PROPOSED IMPROVEMENT
BRIDGE PROJECT
TOWN OF CAVENDISH
COUNTY OF WINDSOR
VT 131 (MAJOR COLLECTOR)
BRIDGE NO 1

RECORD PLANS

Vermont Agency of Transportation
RECEIVED
ON: November 25, 2013
and Checked for
CONFORMANCE
BY: Rob Young DATE: 12/10/2013

THE STAMPED DOCUMENTS ARE HEREBY:

ANCHOR BOLT PLAN

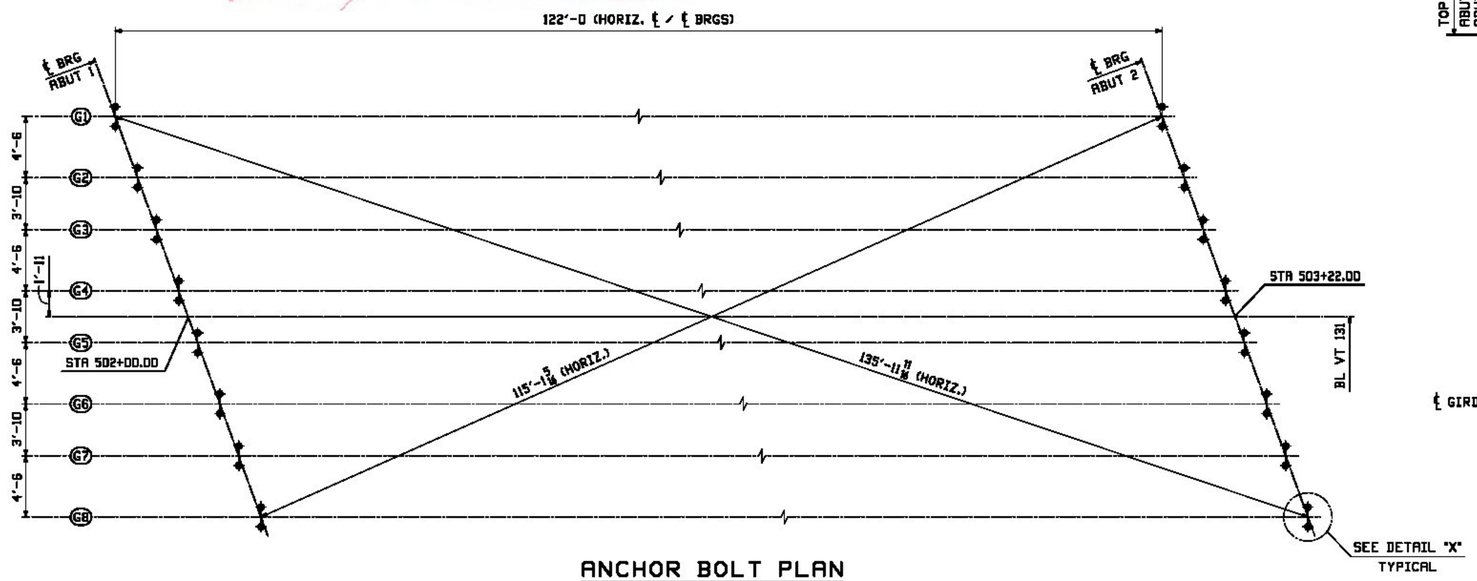
NOTE: REVIEW OF THIS DRAWING IS FOR BEARING ASSEMBLY CONFORMANCE ONLY

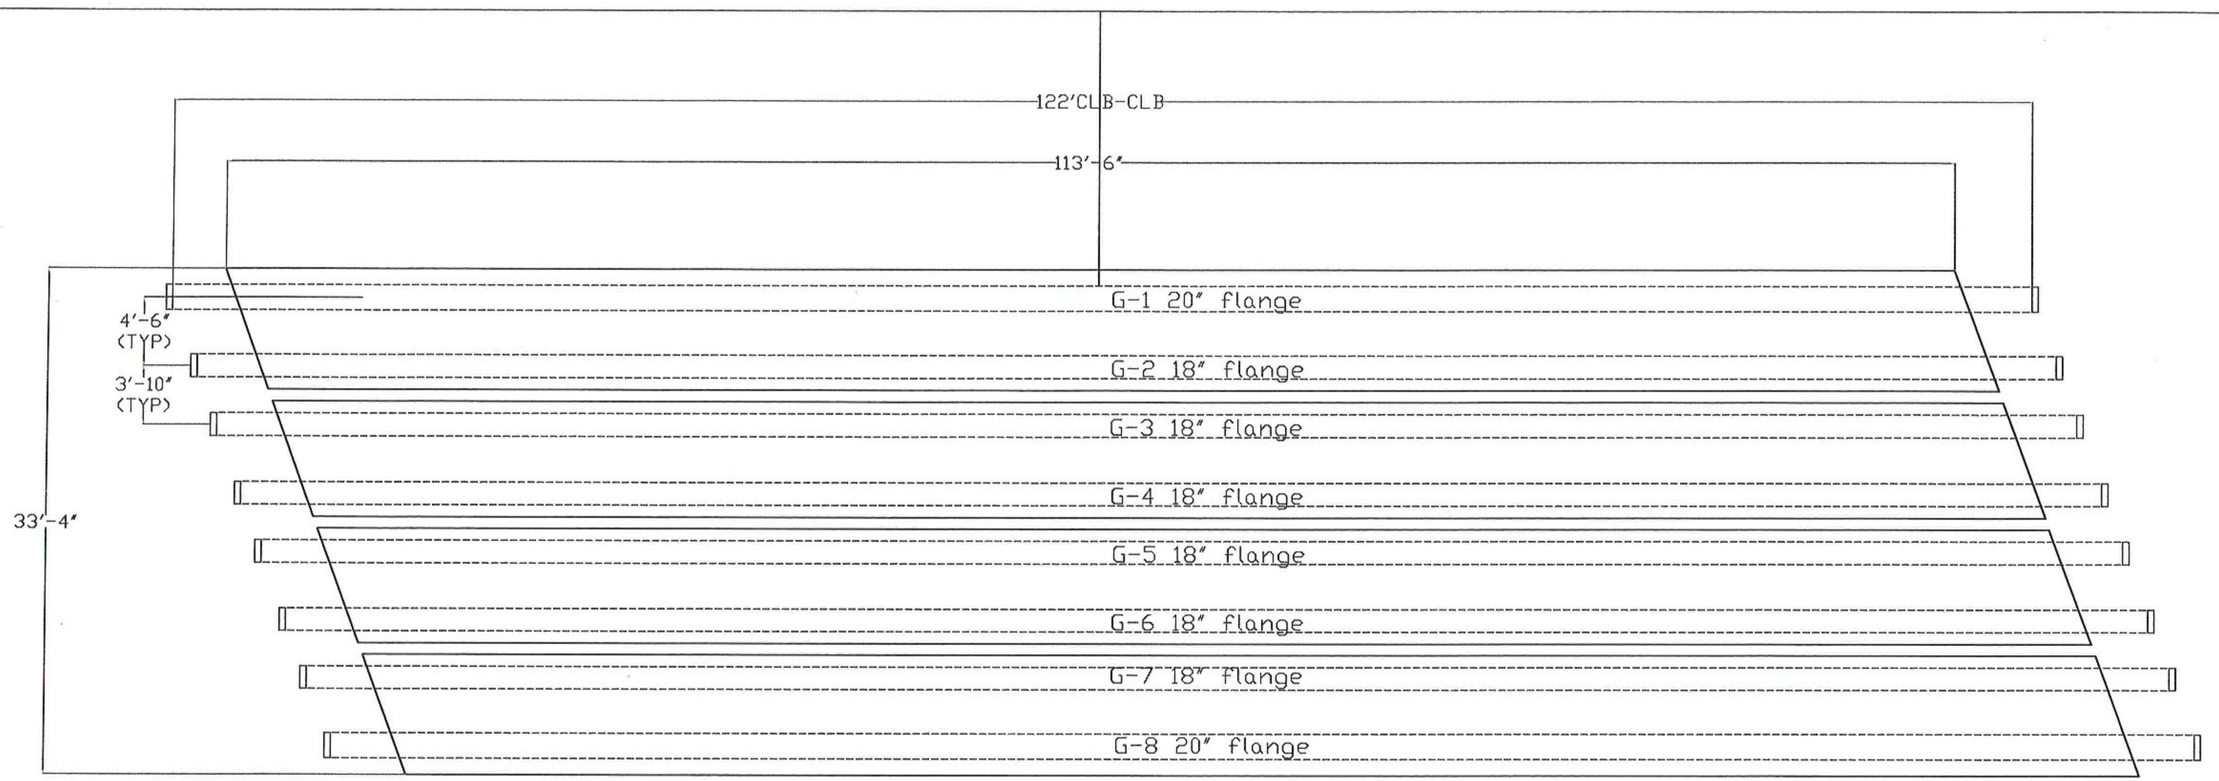
It should be understood that the Erection plan needs to be submitted and accepted before the structural steel gets to the site.

APPROACH SLABS E,F,G,H
CASTING LAY-OUT

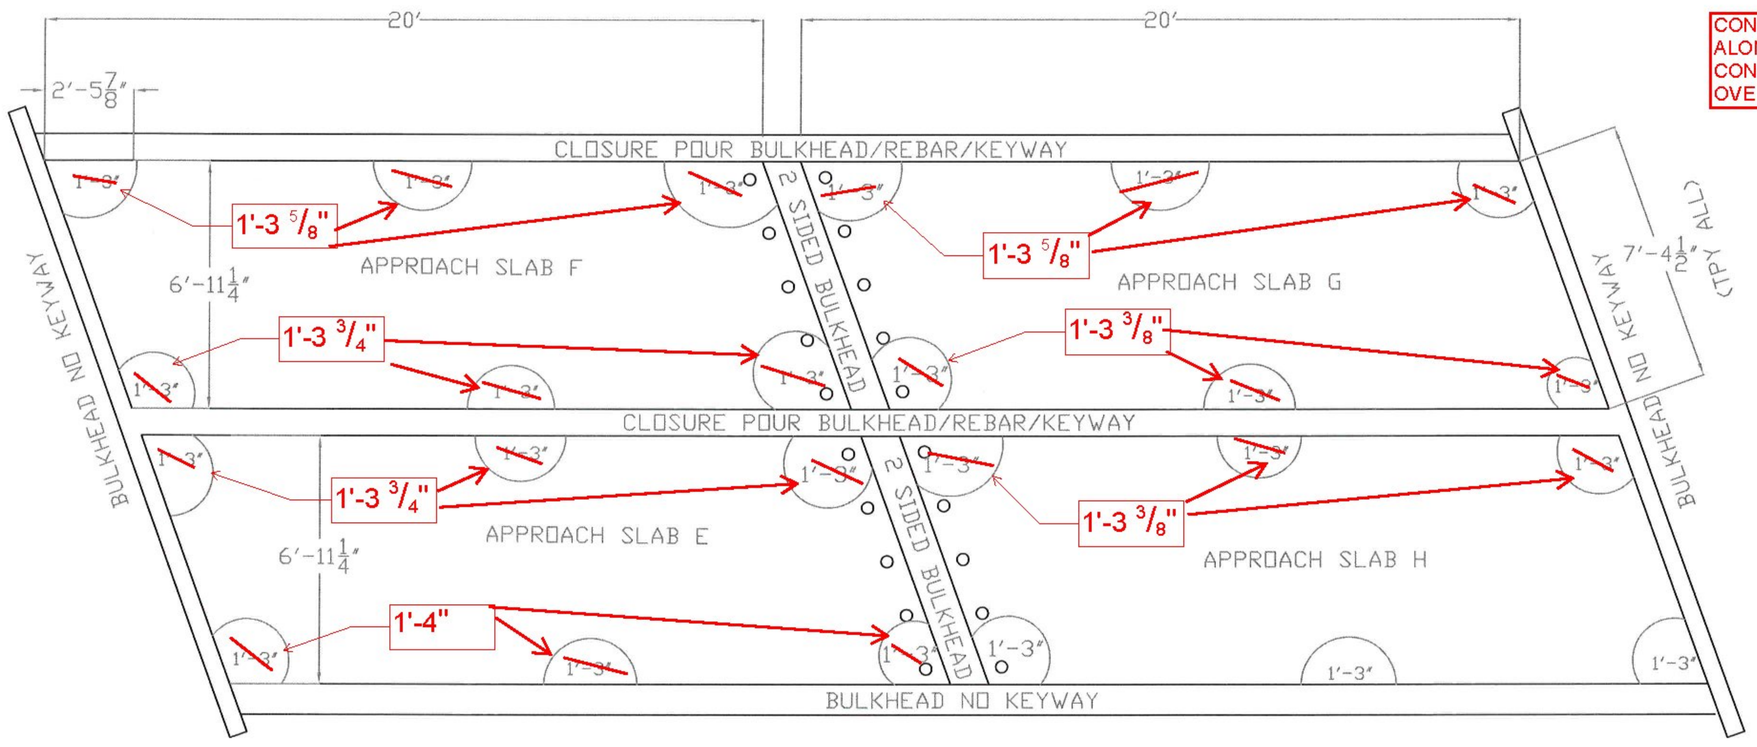
APPROACH SLAB # 2 THICKNESS HAS BEEN CHANGED BY THE PROJECT MANAGER TO A CONSISTENT 1'-3"

CONSTANT THICKNESSES ALONG EDGES, BUT NOT CONSTANT THICKNESS OVERALL

ABUTMENT 2 BEARING LAY-OUT

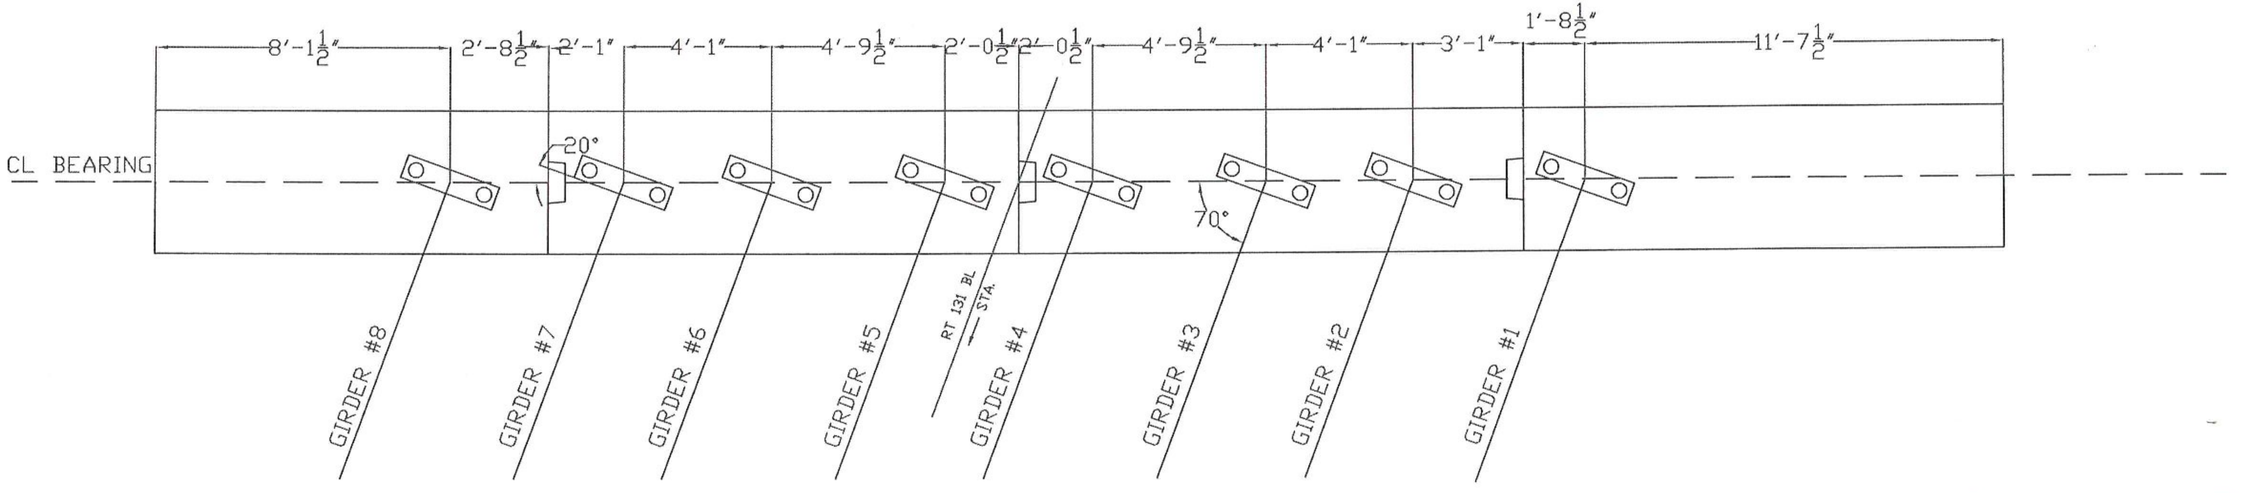
REVISED DIMENSIONS FROM FACE OF VERTICAL CONSTRUCTION JOINT
